**Product Update: 2016–20 HR-V Software Update and CVT Inspection**Supersedes 21-046, Dated June 1, 2021, to revise the information highlighted in **yellow**.**AFFECTED VEHICLES**

**REVISION SUMMARY****Under CVT INSPECTION, step 10 was updated, and image was added.****BACKGROUND**

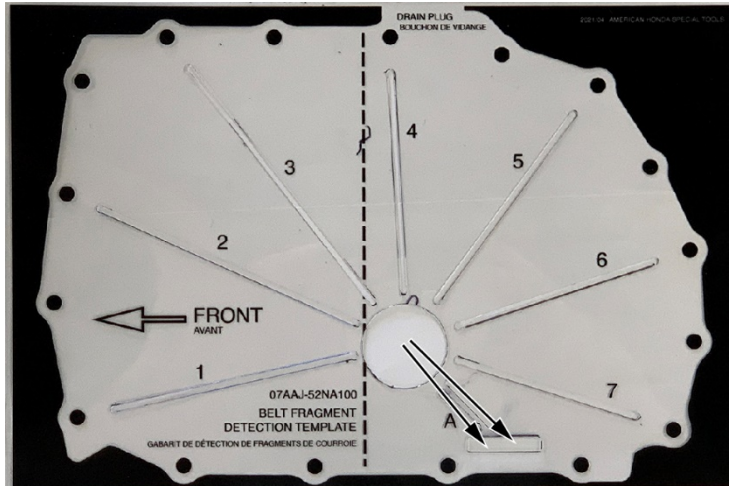
10. After tracing all 7 lines from the outside to the inspection area, let go of the magnet to see if it sticks in place. If the magnet sticks to the oil pan in the inspection area there is a problem with the transmission. Write the last 7 characters or digits of the VIN on the bottom of the oil pan. Take a clear picture of the magnet sticking to the oil pan in the inspection area, make sure the VIN characters are clearly seen in the picture, then go to service bulletin 21-047, *Warranty Extension 2016 - 20 HR-V CVT Premature Belt Deterioration*. If the magnet does not stick to the oil pan, go to the next step.
